Technical Note

1.1 Mayer Brown Ltd has prepared this Technical Note in response to the most recent consultation response from Hampshire County Council, dated 27th May 2021, within their role as local highway authority (LHA) and relating to the Transport Assessment (TA), subsequent Addendums and Travel Plan submitted as part of Havant Borough Council planning application APP/20/01221 for the proposed construction of a Lidl foodstore on land adjacent to the B&Q store on Purbrook Way, Havant.

title
**PROPOSED LIDL FOODSTORE
PURBROOK WAY, HAVANT**

scale 1:250 @ A3	drawn by RB	checked by -
date JUNE 2021	cad file 210706 - B&Q ARM VISIBILITY	
drawing number B/LIDLPURBROOKWAY2.1/07-02	rev. -

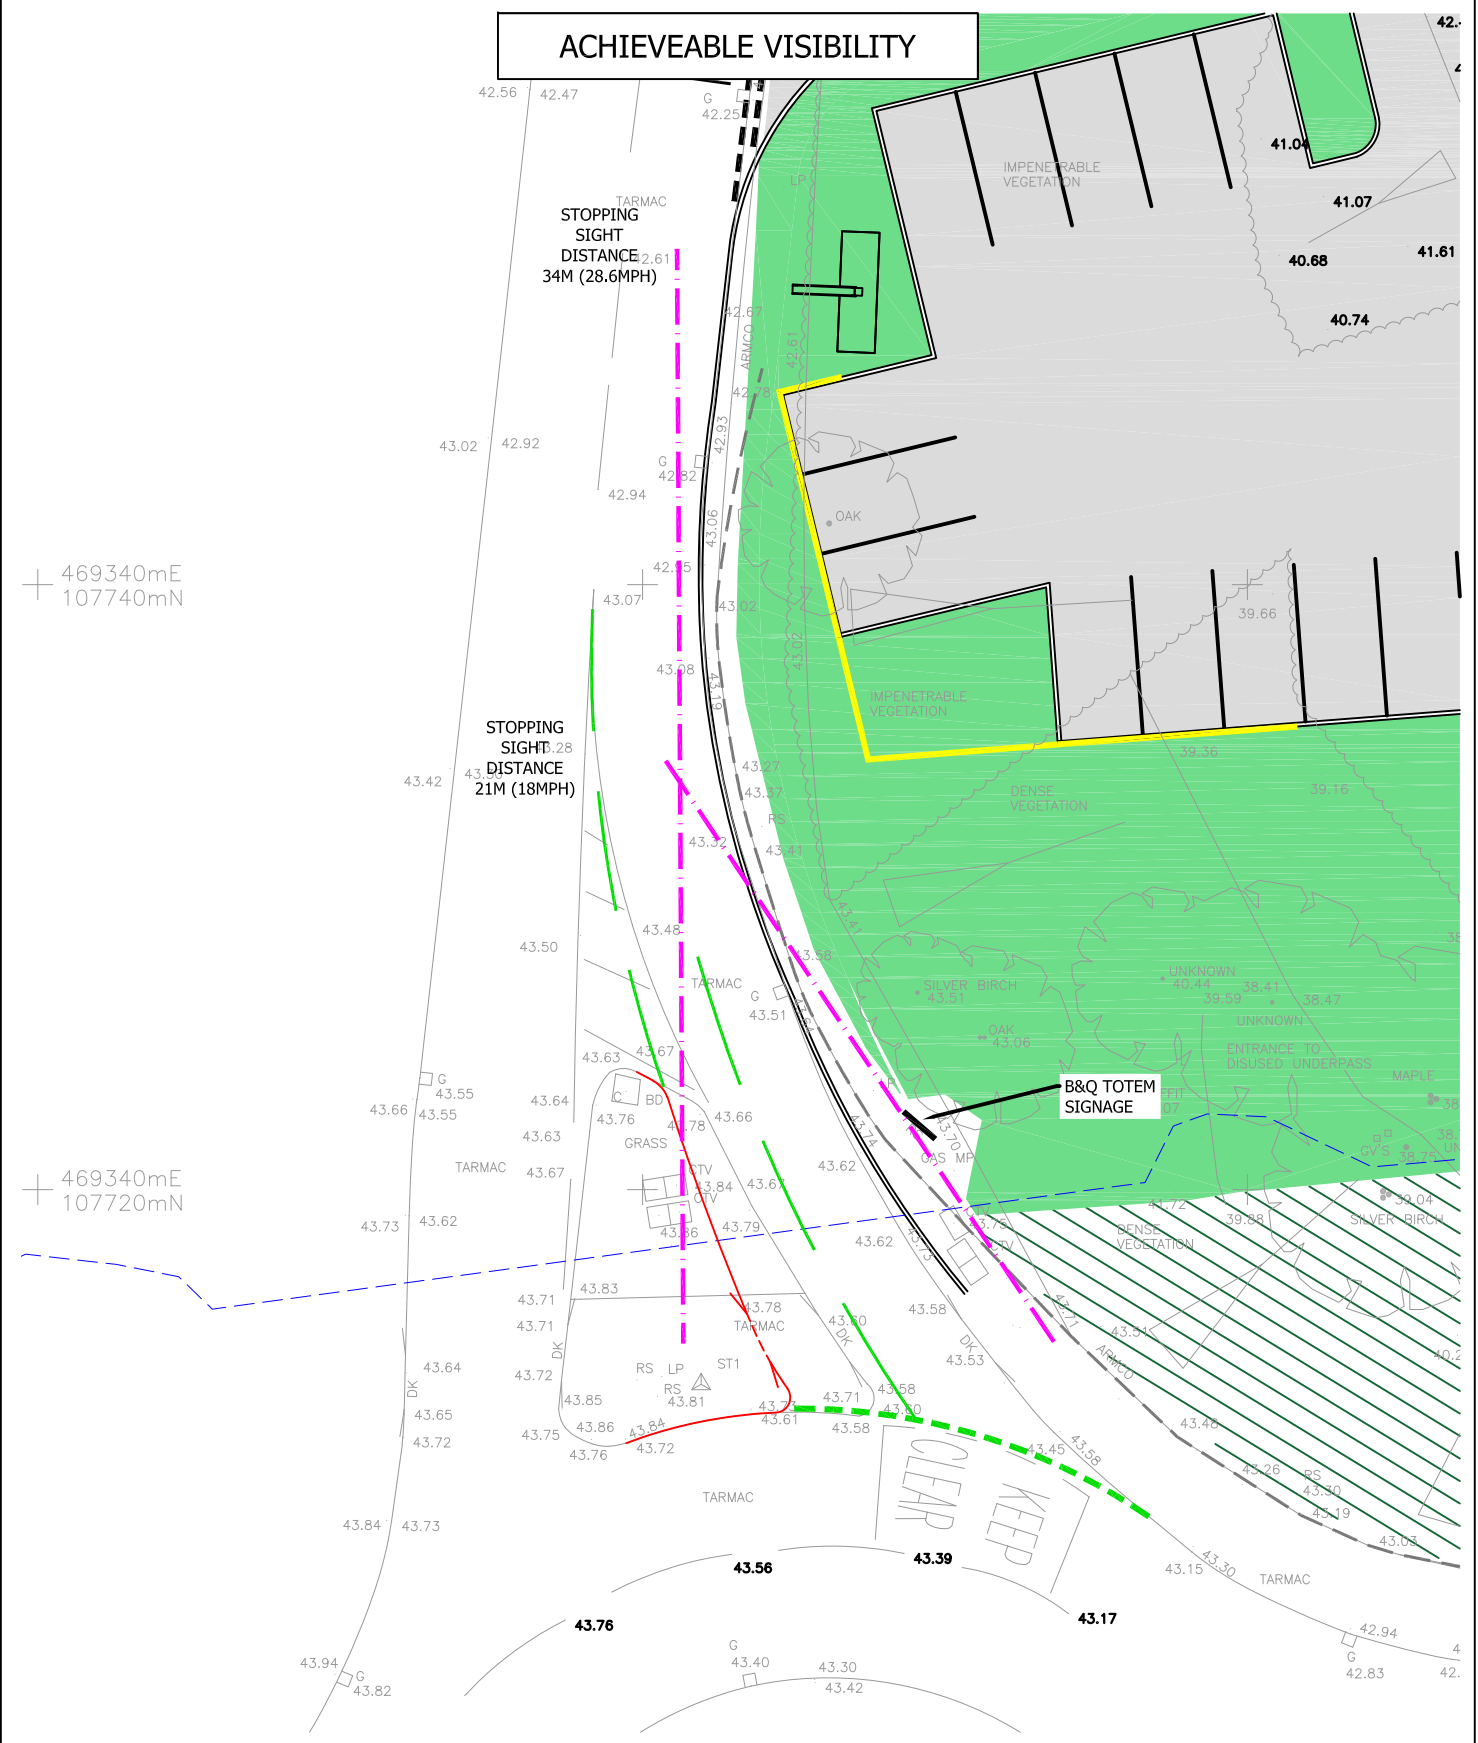
Whilst the Auditors accept that the B&Q totem sign will partially obstruct forward visibility splays to the pedestrian crossing point, the Auditors consider that if vegetation is trimmed back to provide the SSD visibility splays indicated on the drawings provided and maintained clear of vegetation, then this would significantly increase the margin of safety at the roundabout junction.

Retained / proposed planting or trees would be set back sufficiently so as not to encroach into the SSD visibility splay envelope shown on drawing B/LIDL PURBROOKWAY2.1/07-02 (**Appendix A**) once fully mature, or consist of low-level planting (<0.6m in height) within the SSD visibility splay envelope.

scale	1:200 @ A3	drawn by	RB	checked by	-
date	JUNE 2021	cad file	210708 - B&Q ARM		
drawing number	B/LIDLPURBROOKWAY2.1/06	rev.	A

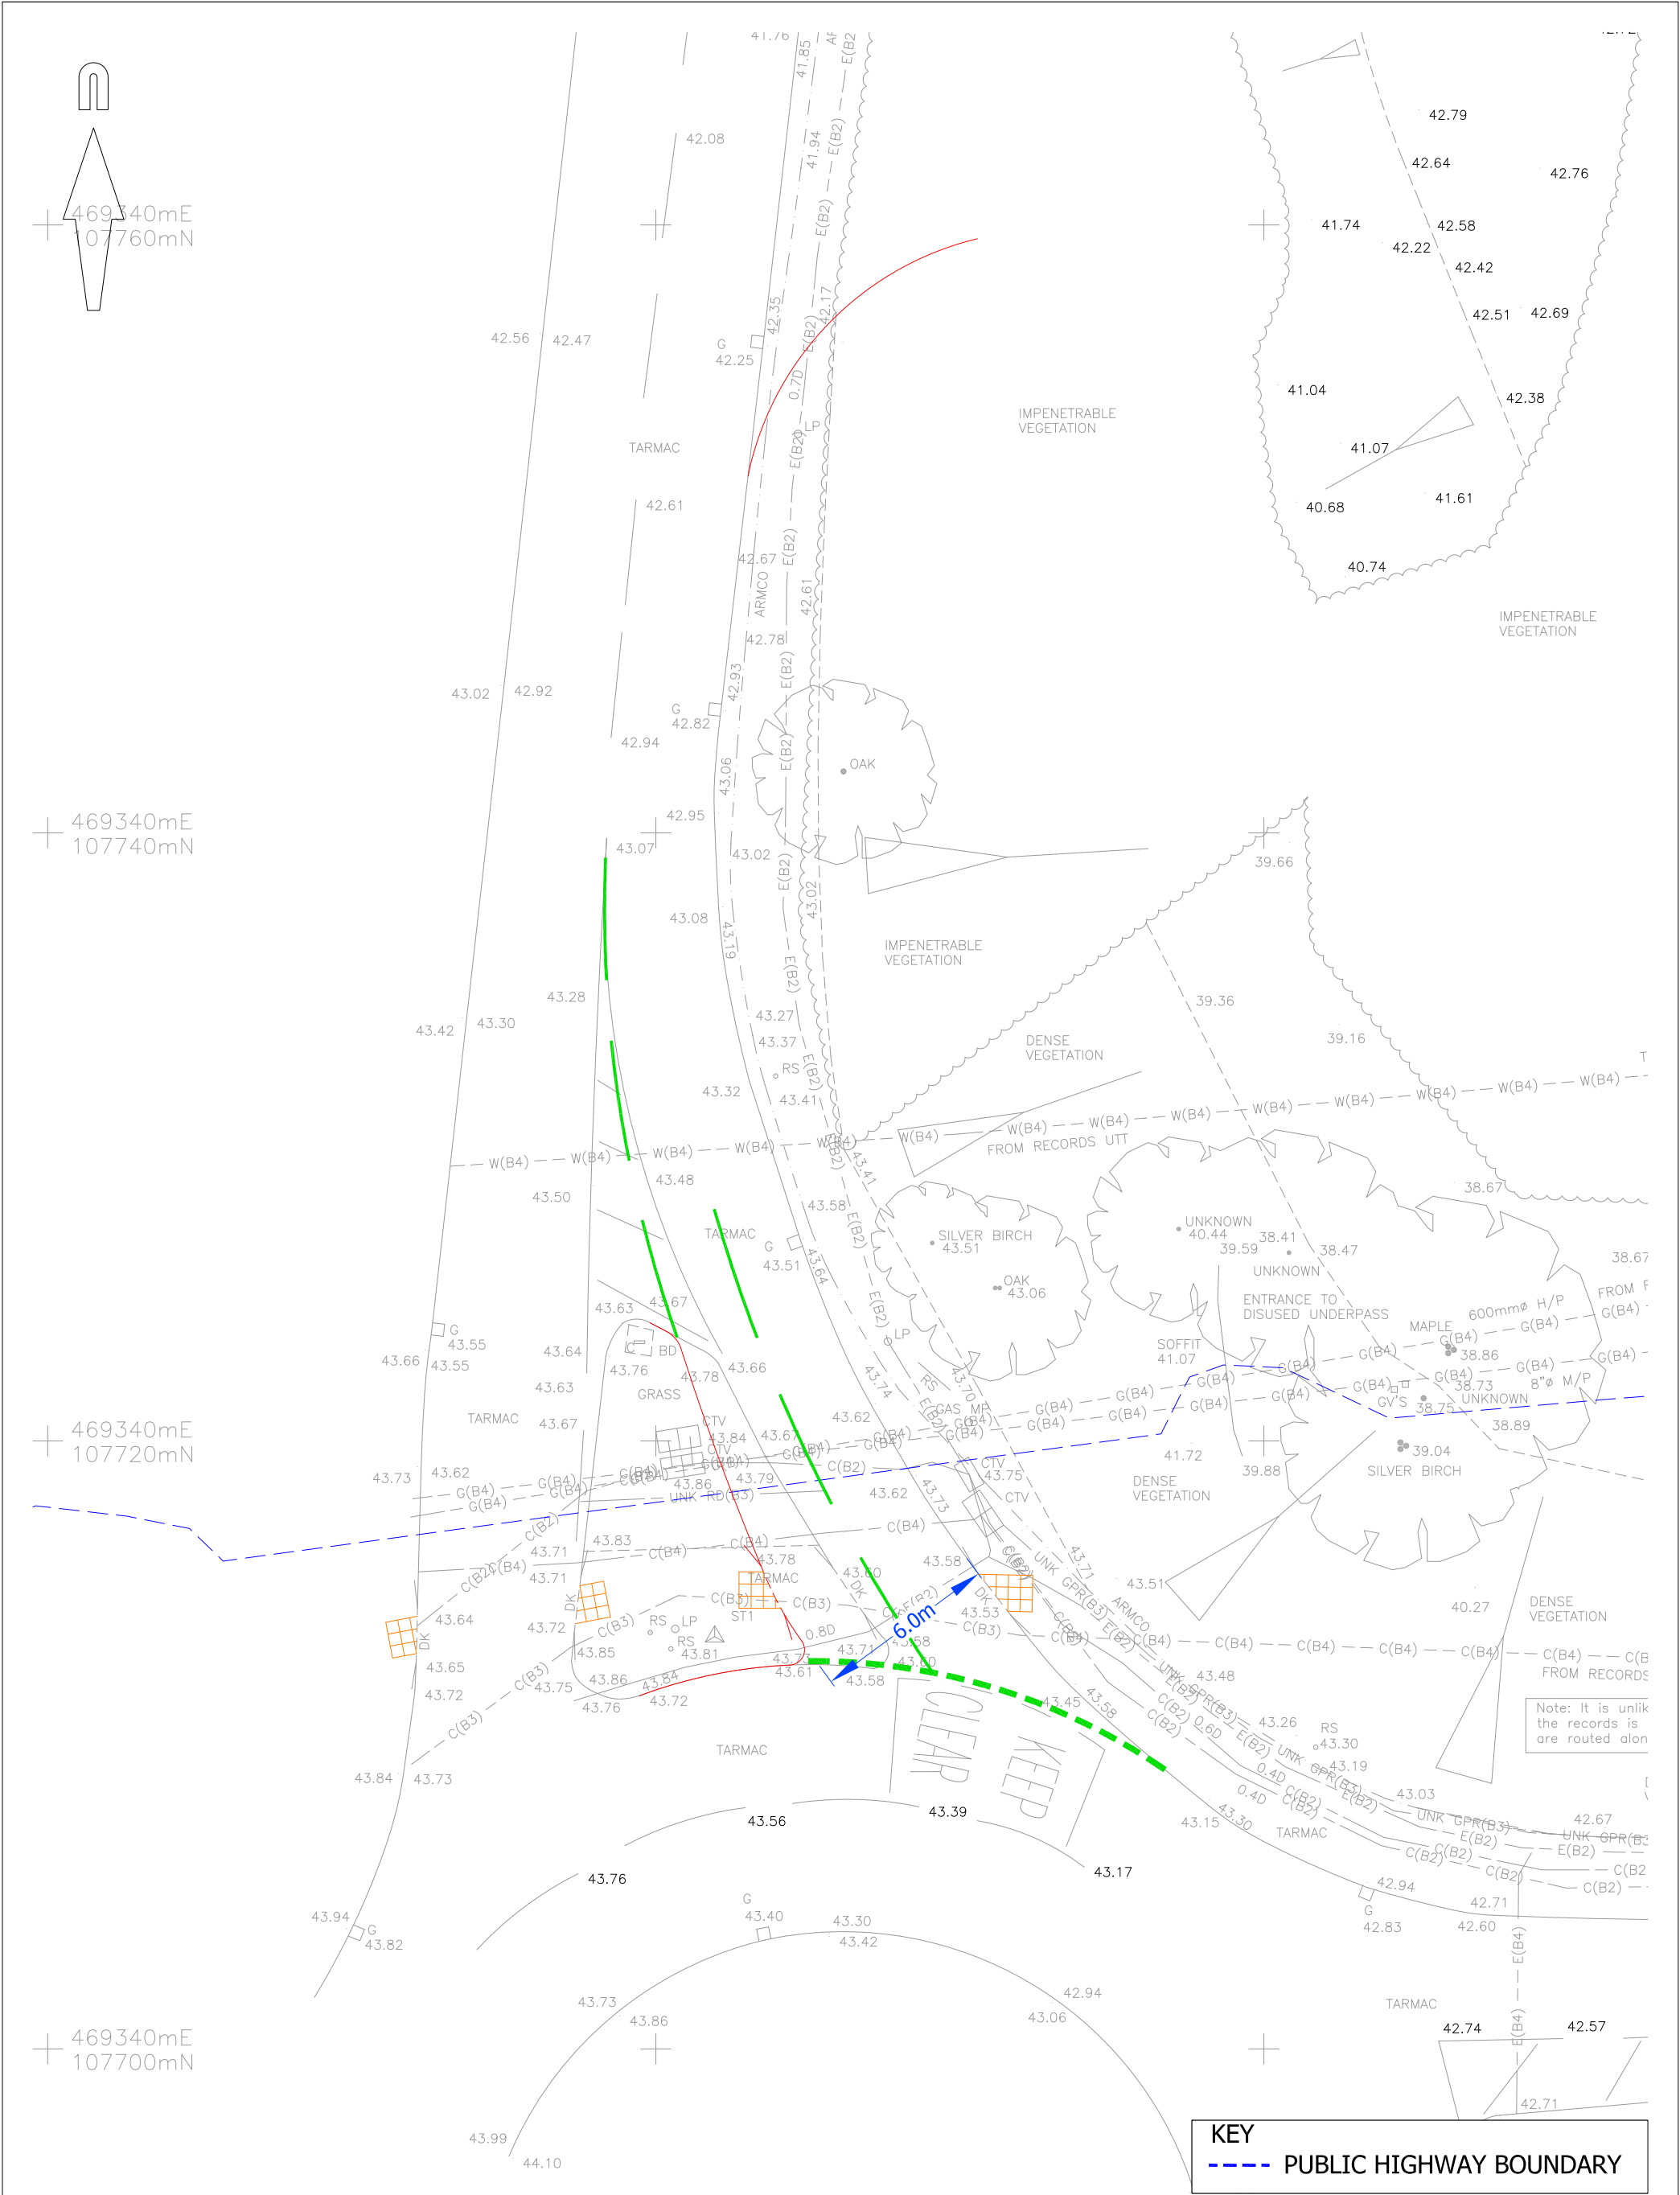
- 1.62 In relation to the A3(M) roundabouts improvement works, the LHA consultation response dated 16 January 2020 noted that *“Whilst there is likely to be some capacity benefits provided by the proposals, the proposed improvements are considered unlikely at this stage to mitigate the impact of development trips from the site. The applicant should engage with the Highway Authority to discuss alternative junction improvement schemes at this location.”*

- 1.77 A slightly amended scheme has been considered, with a 6m entry width to provide two 3m lanes at the give way lane and a resulting effective flare length of 14m. A plan showing the proposed junction amendments is provided in **Appendix J**.

- 1.79 The highway improvement scheme would increase the pedestrian / cycle crossing distance at the B&Q egress arm from to 4.8m to 7.3m.
- 1.80 The ARCADY model for the A3(M) roundabouts has been updated to reflect the revised B&Q arm parameters, with a summary of the capacity modelling results for the with development scenarios shown in **Table 6**.
